SUBDIVISION COMMITTEE DEPARTMENT CLEARANCE

TRACT MAP NO. 072939

TENTATIVE MAP DATED 12/16/2014
EXHIBIT MAP 12/16/2014

MAJOR LAND DIVISION TENTATIVE TRACT MAP NUMBER 072939

TENTATIVE TRACT MAP #072939
183/205 E. PALM AVENUE
ALTADENA, CA
APN: 5833-019-31, 35

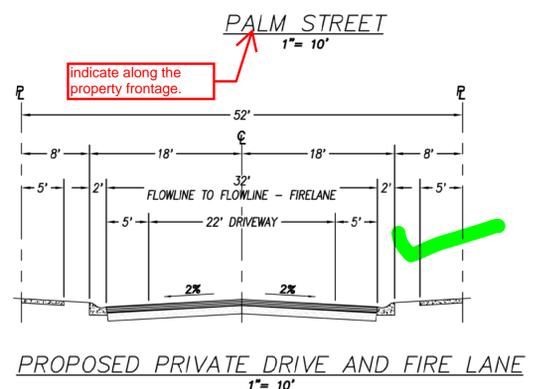
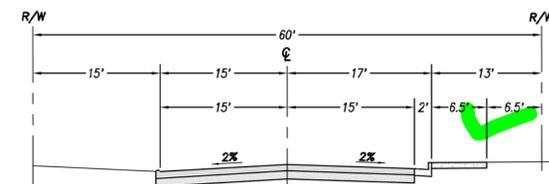
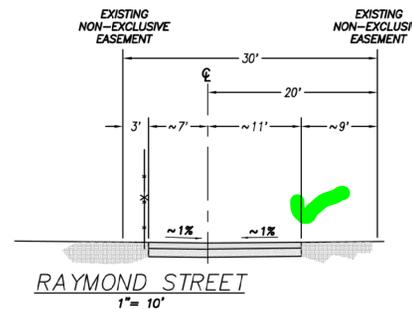
As previously requested, show all existing improvements 50' on either side of the parcel

As previously requested, indicate unused driveway to be closed

CONDOMINIUM EXHIBIT

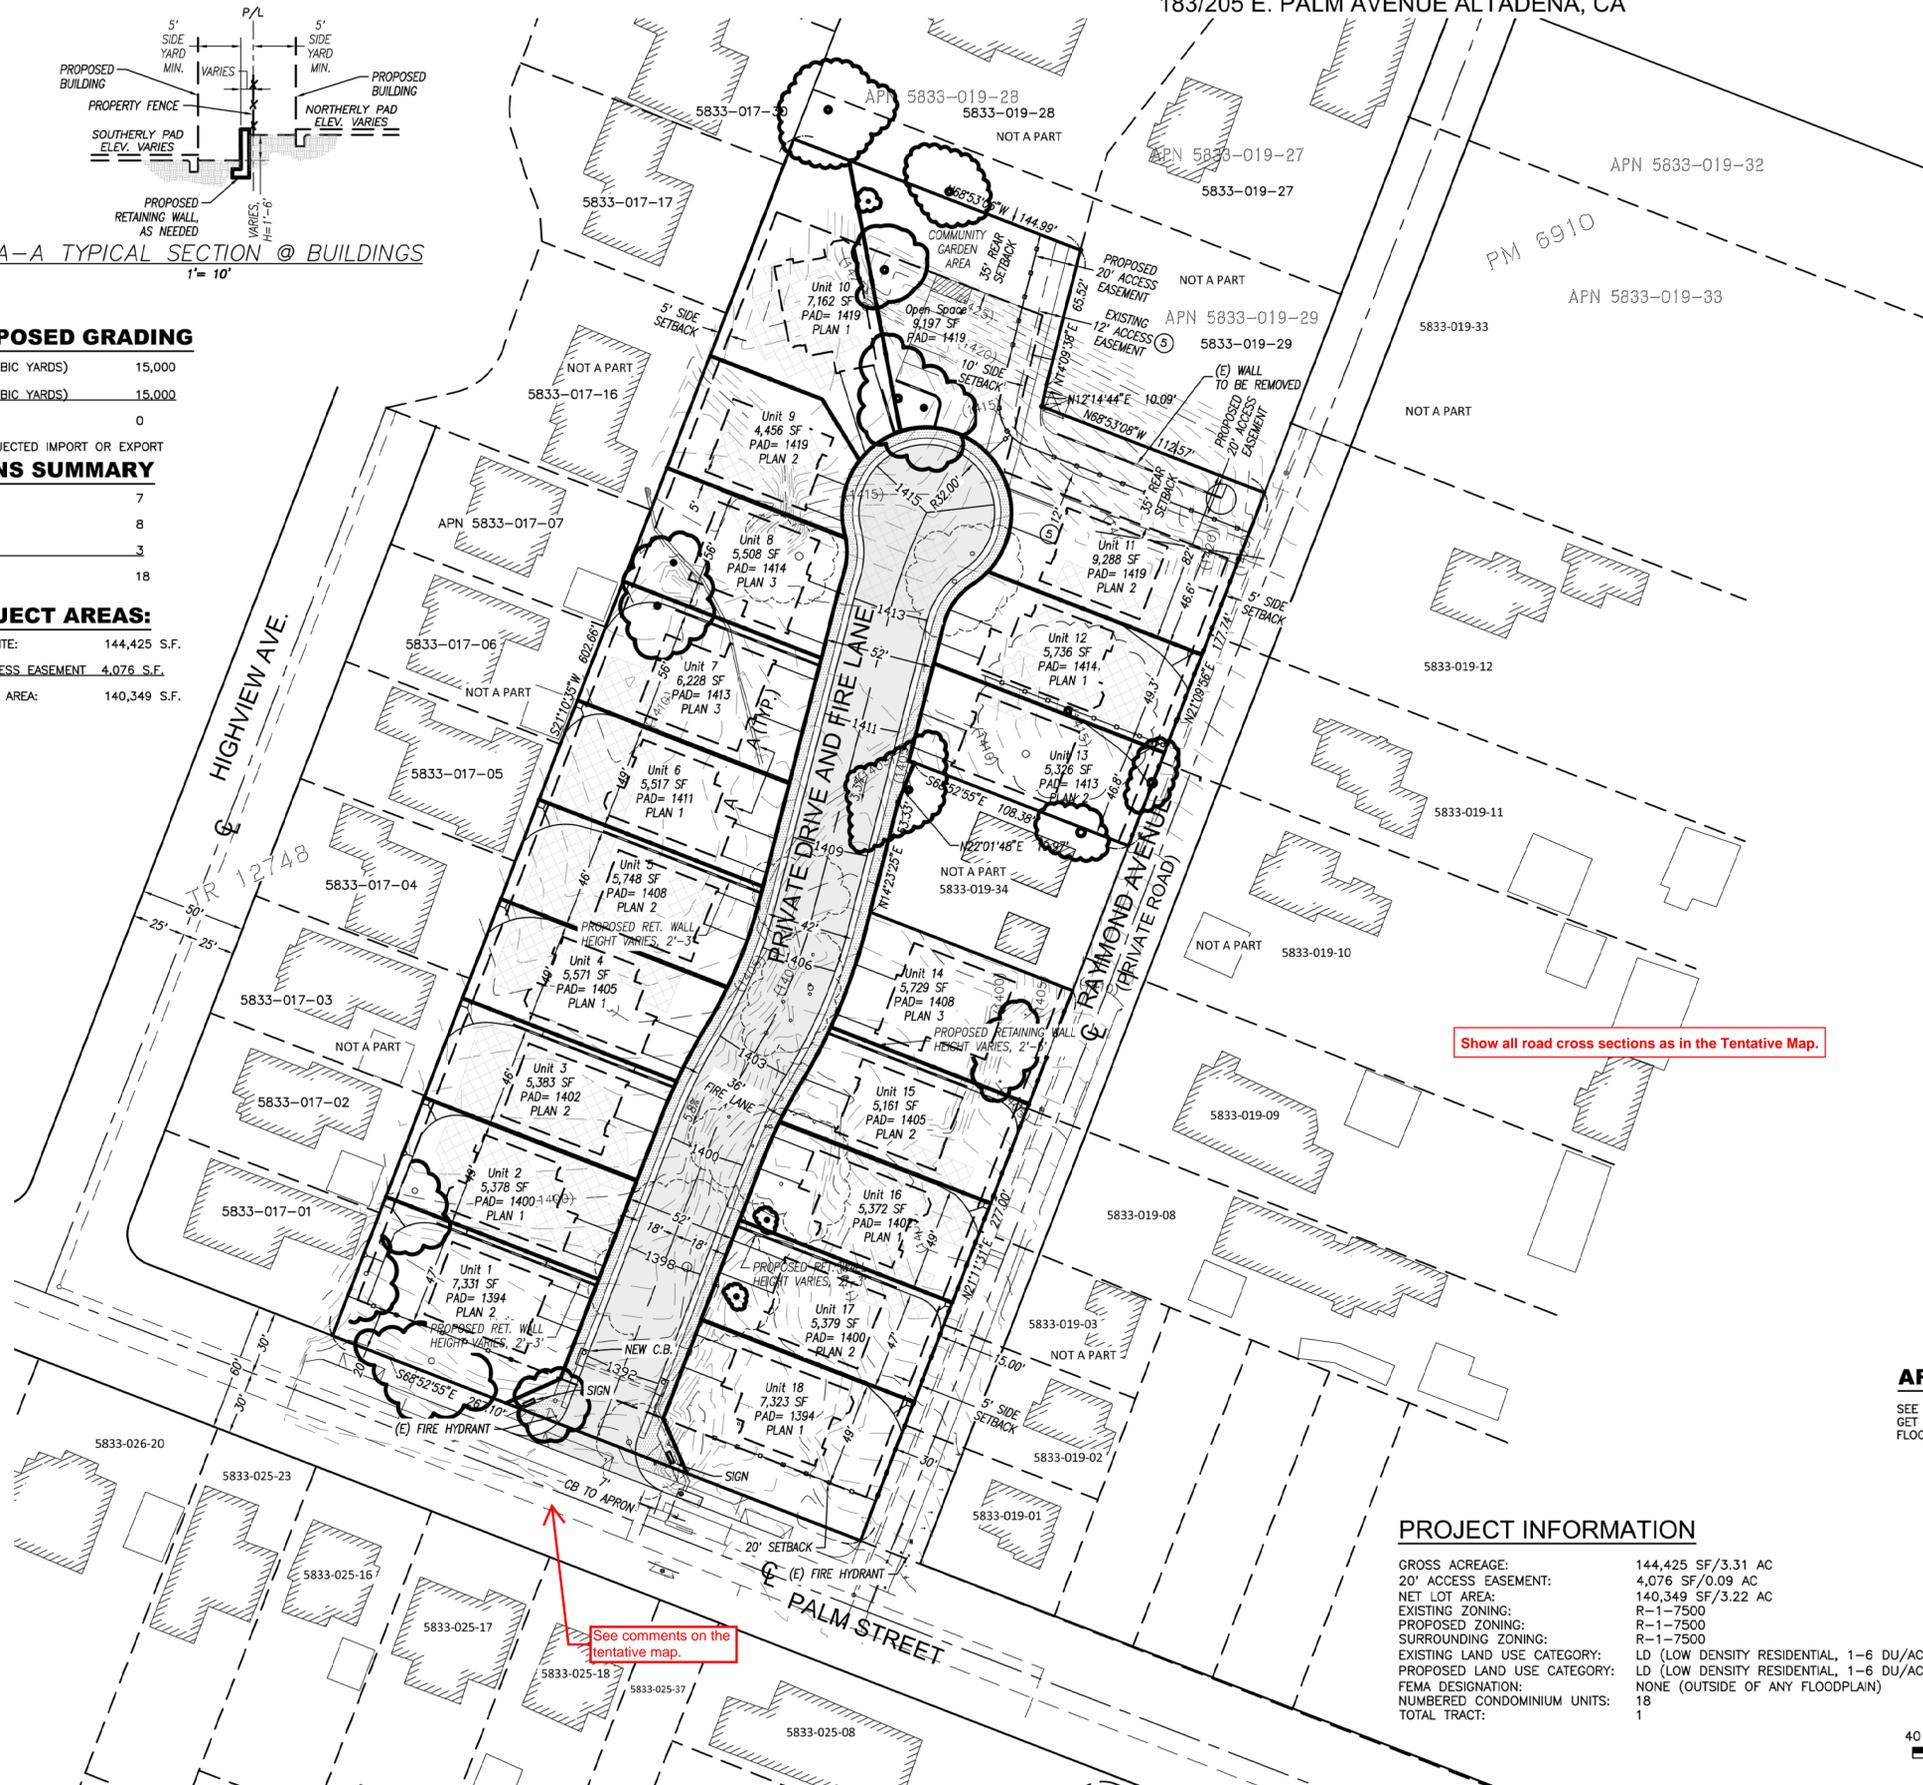
Show all road cross sections as in the Tentative Map.

See comments on the tentative map.
